MCHC-10, 16, 20, 25

Profile change Notification

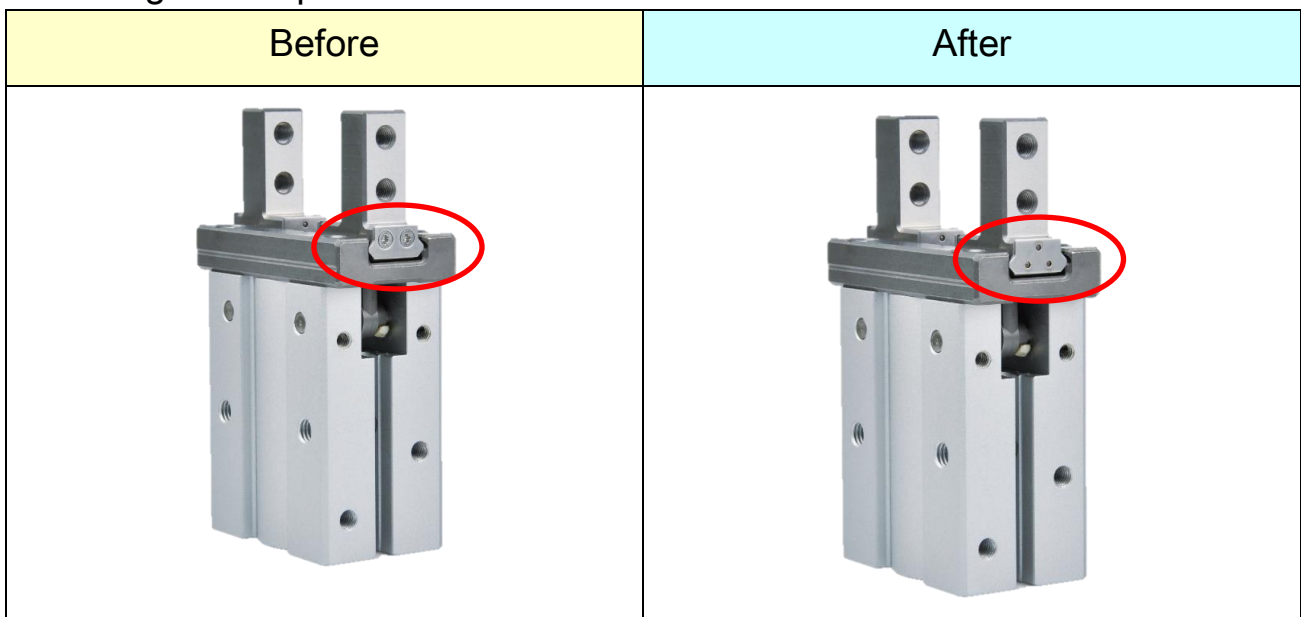
Profile changes due to manufacturing process optimization.

3. Change descriptions
